Product Change Notification

PCN #: 4B-2022

DATE: 04/07/2022

SSD50NBT

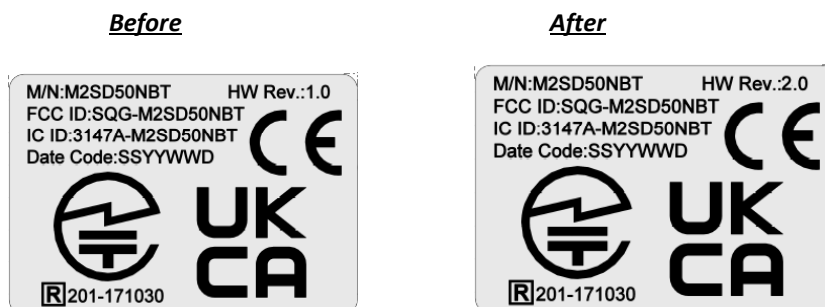
- Add hardware version code Rev 2 to product label
- Add UKCA logo to meet UK regulatory requirement after Brexit
